AGENDA
CALIFORNIA TRAFFIC CONTROL DEVICES COMMITTEE (CTCDC)
February 2nd, 2011 Meeting (Start Time 9 a.m.)
1000 Ulatis Drive (Ulatis Community Center)
City of Vacaville, CA 95687

11-2 Proposal to adopt revised Text, Tables, and Figures in Part 6 of the CA MUTCD 2010

Table 1: Summary of Proposed Revisions to Part 6

Figure 6H-21. Lane Closure on the Near Side of an Intersection (TA-21)

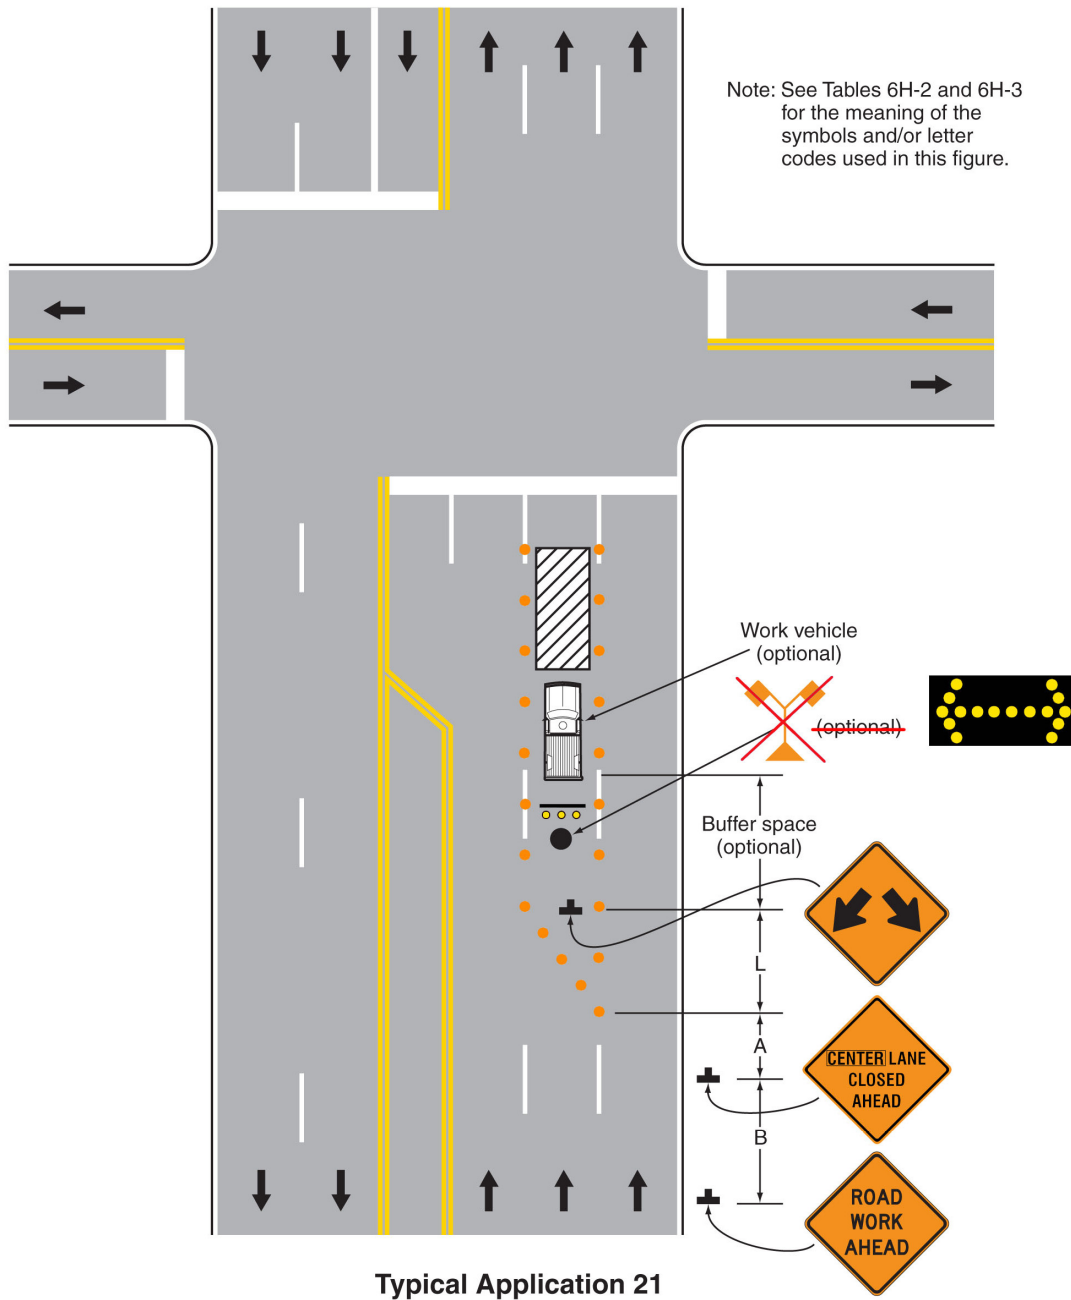
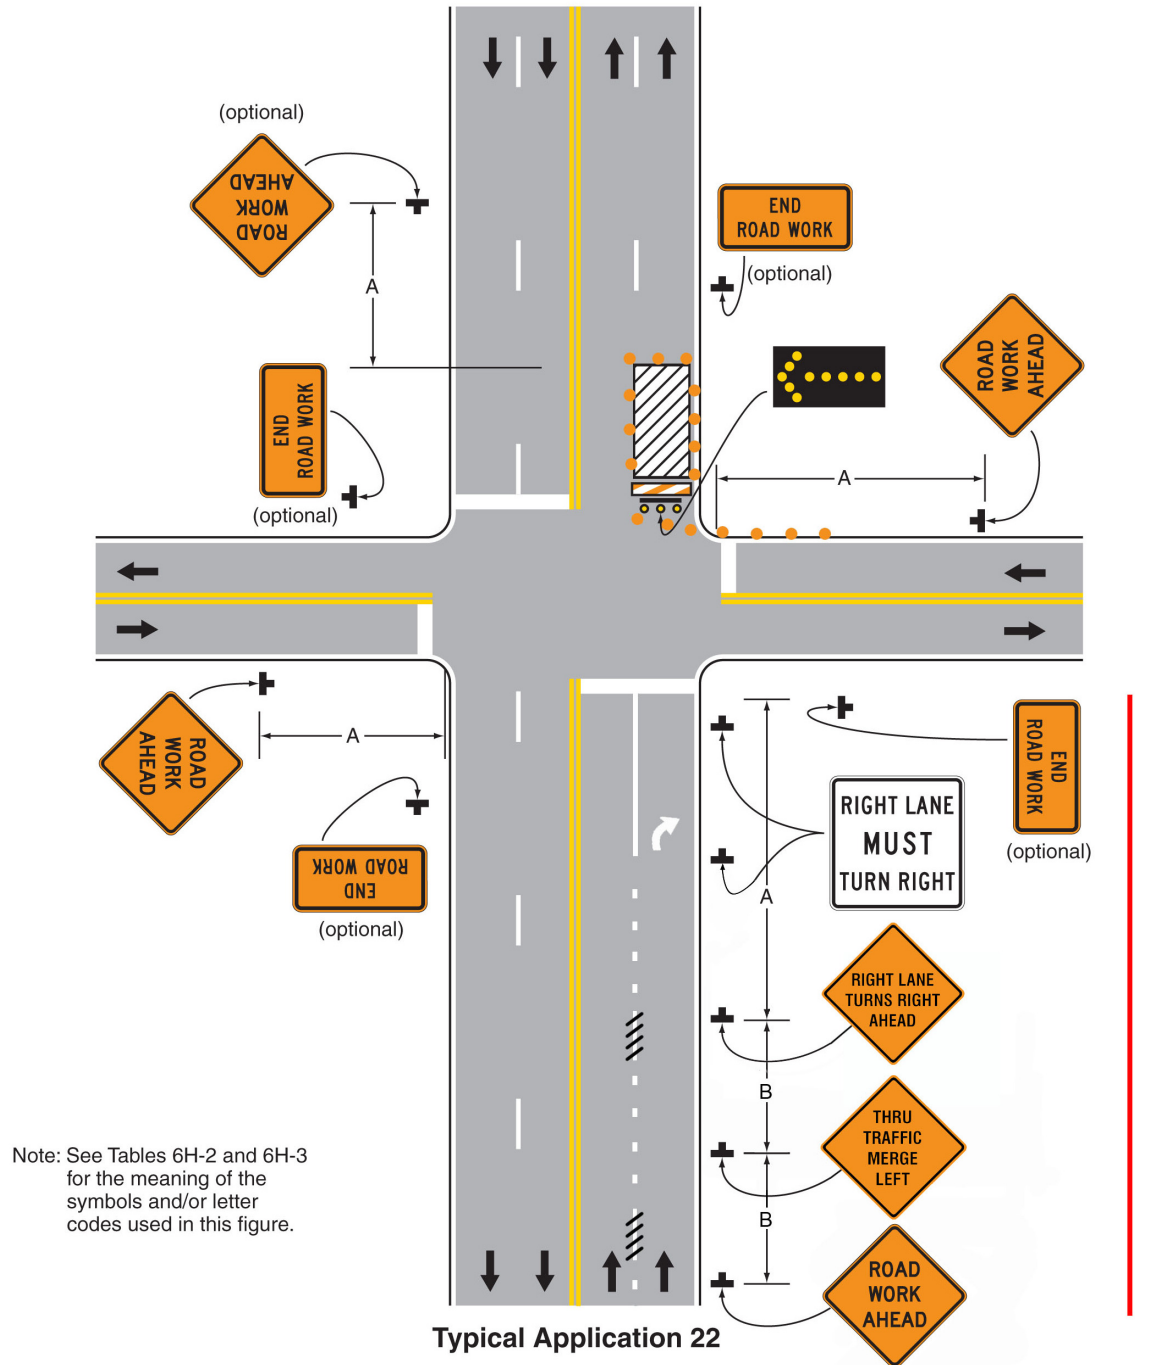
12	Figure 6H-21	Revise figure to show on Arrow Panel, instead of a Flag Tree	Arrow Panels are recommended (Guidance) for lane closures in Section 6F.56.
13	Figure 6H-22, possibly Figure 6H-22A(CA)	Revise figure to show pavement markings as per Figure 3B-12(CA) Sheet 3 of 3	Trap lanes do not provide orderly operation without the lane drop pavement markings. Section 3B.09 mandates these markings as a Standard.
14	New Figure, possibly Figure 6H-22B(CA)	Similar to the above figure, but with the option to close the lane, instead of entrapping it with lane drop reduction markings	Figure 6H-22 is not effective, without lane reduction markings or a lane closure. The new Figure illustrates an option that is used frequently in urban areas.
15	Figures 6H-23, 24, 30, 31, 32	Revise to delete the word “Optional” below the Arrow Panels	Arrow Panels are a Guidance requirement, not an Option in Section 6F.56 when a lane is closed.

Figure 6H-24 · Half Road Closure on Far Side of Intersection (TA-24)

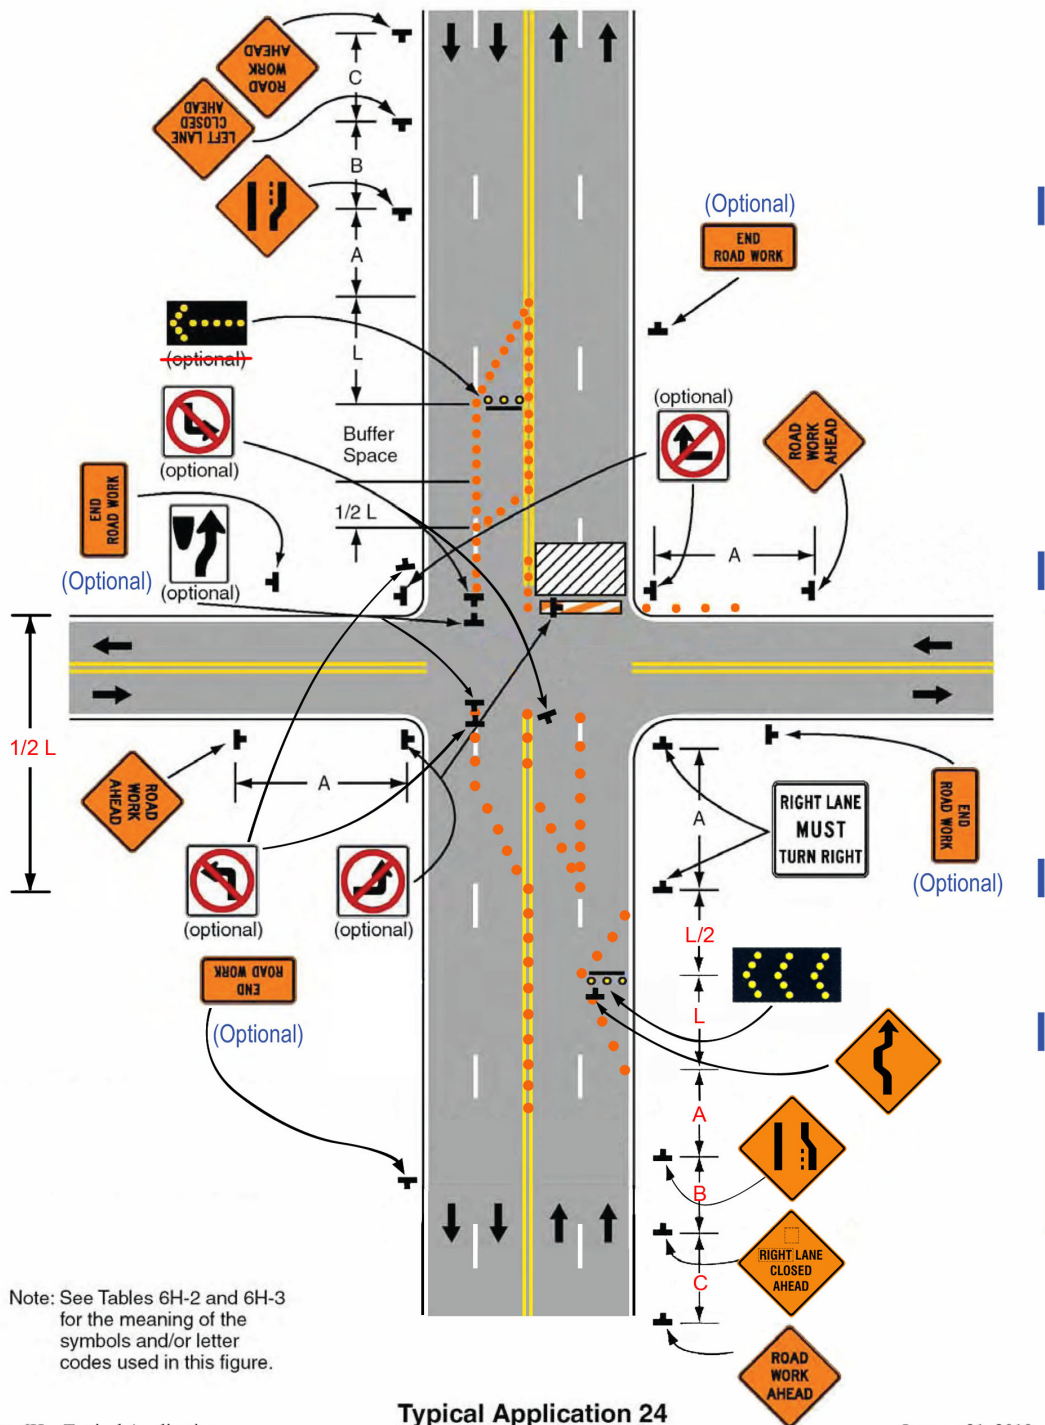
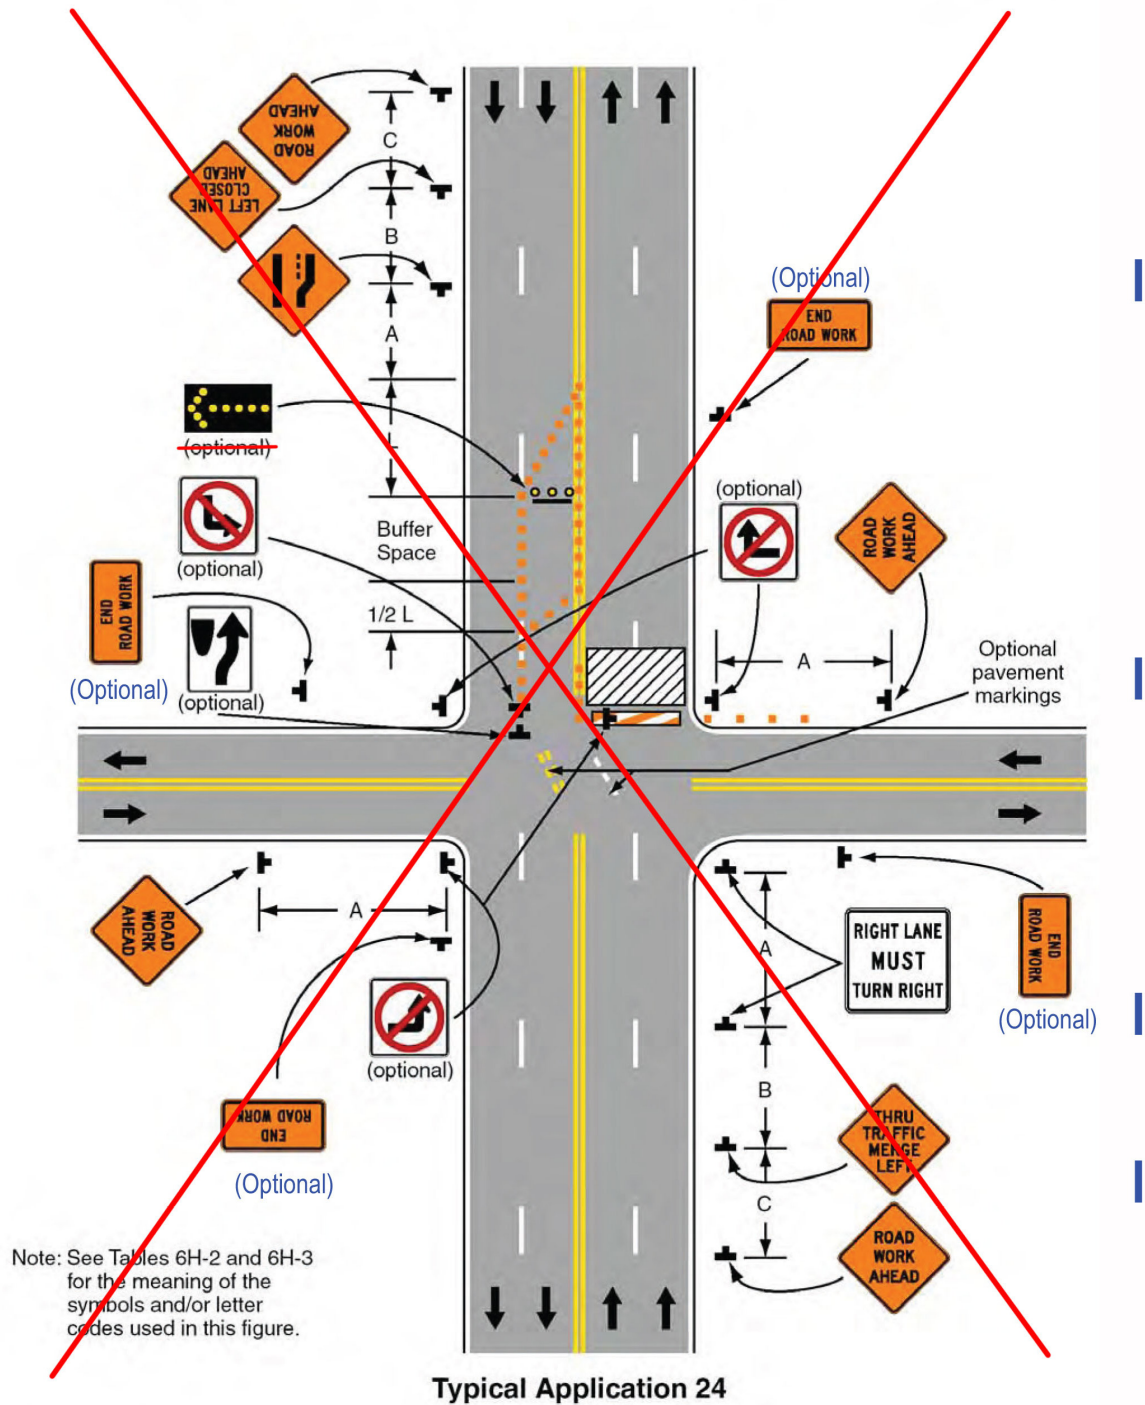
16	Figure 6H-24 (CA)	Revise to show a tapered transition in advance of the intersection	An abrupt, full-lane transition through the intersection is sub-standard.
17	Figure 6H-25	Revise figure to: 1) Show an Arrow Panel instead of a Flag tree; and 2) Channelize thru traffic, to the thru lane to the right, not entrap it to the left turn lane.	Arrow Panels are required for lane closures in Section 6F.56. Also, thru traffic should be channelized to the available thru lane.

Figure 6H-46B(CA). Work in Vicinity of a Grade Crossing

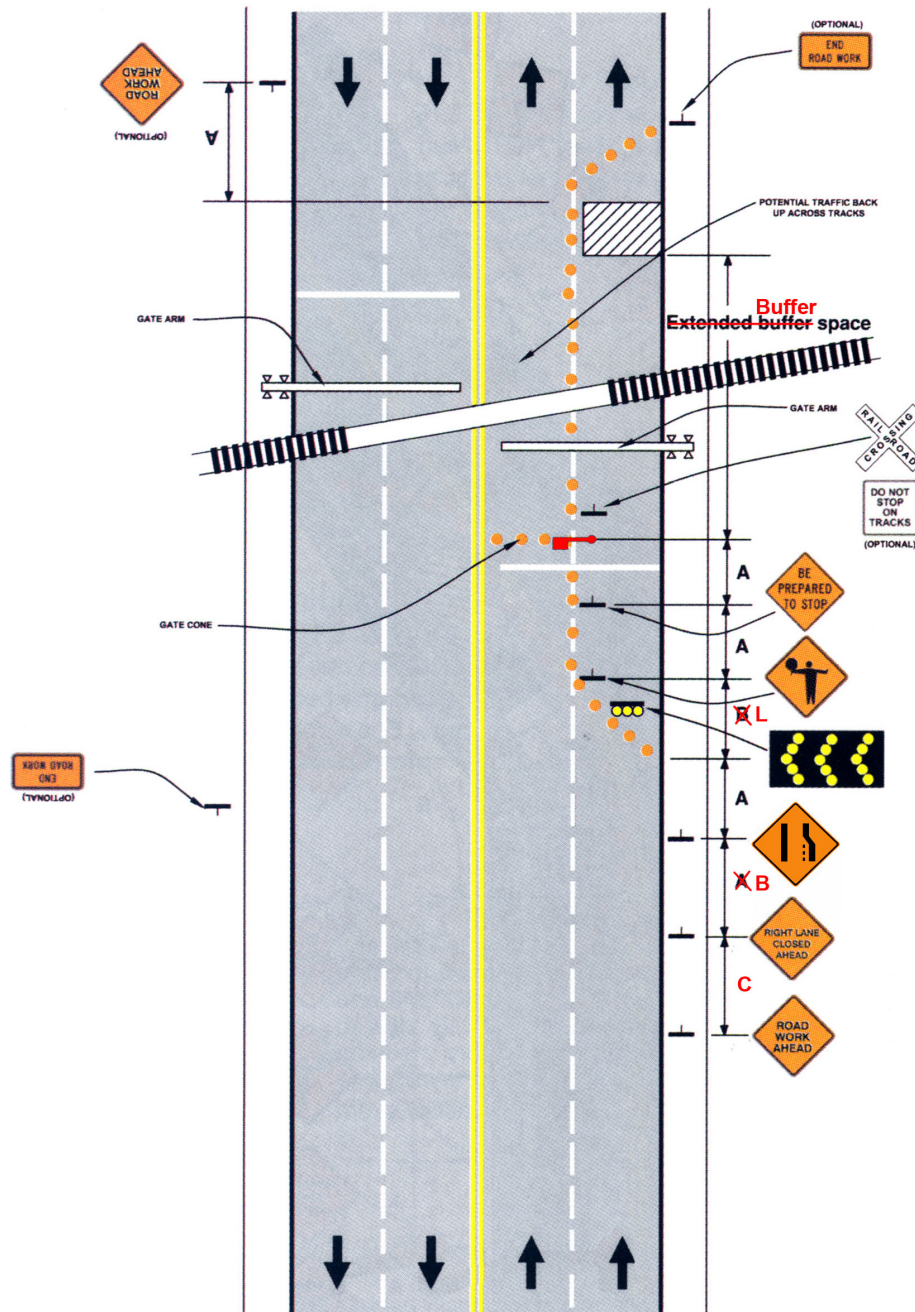
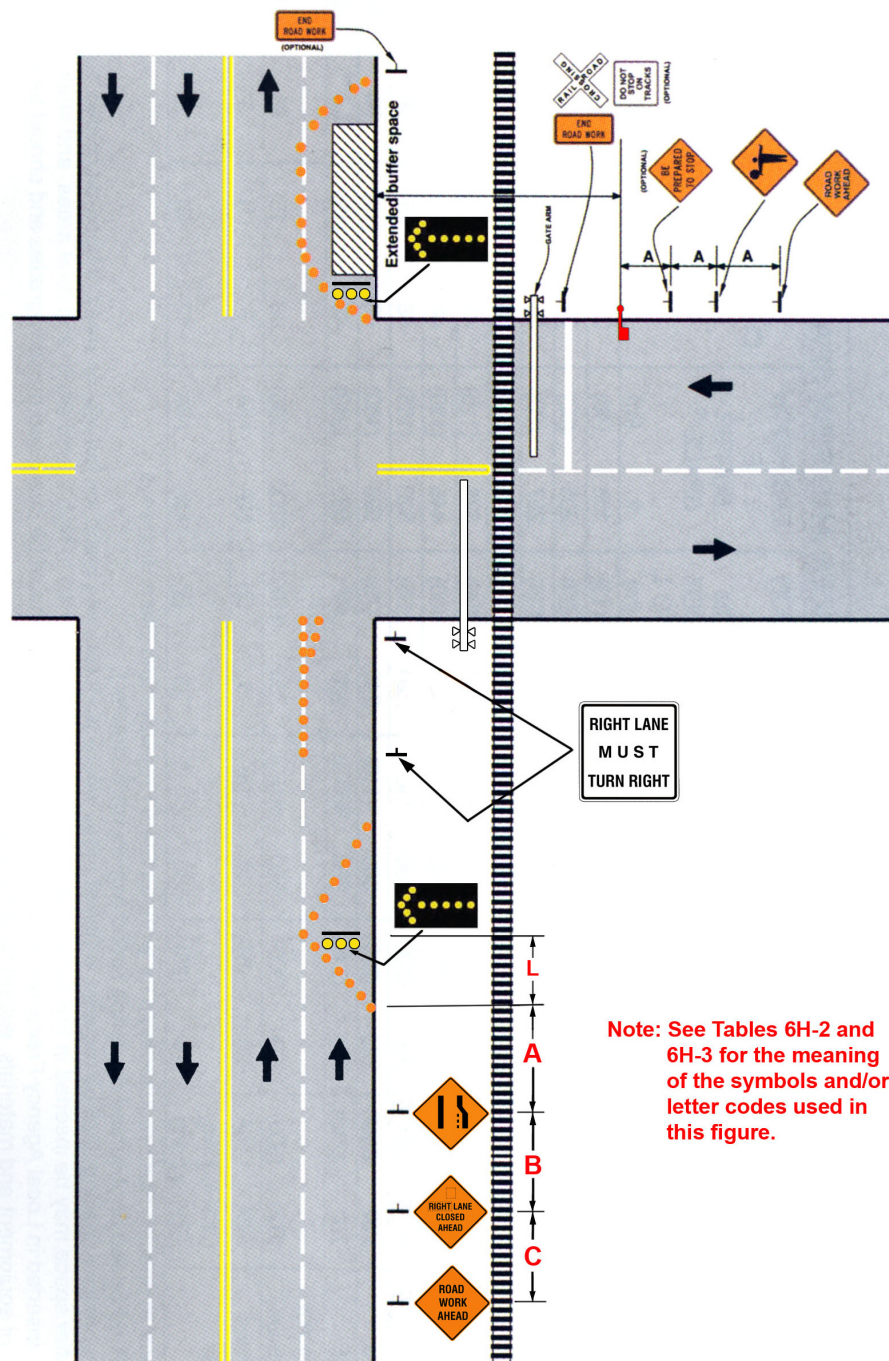
18	New Figure, possibly Figure 6H-46B(CA). Possibly re-number 6H-46 to 6H-46A (CA)	Shows a flagger for a lane reduction near a rail crossing, for queue control. Show the correct flagger symbol in Figure 6H-46A(CA).	Due to the increased probability of queuing across the tracks with a lane reduction, a flagger is needed, as per Section 8A.08 of the 2009 MUTCD.
19	New Figure, possibly Figure 6H-46C(CA)	Shows a flagger for a lane reduction that could impact turning from a side street near a rail crossing	Same reason as above.
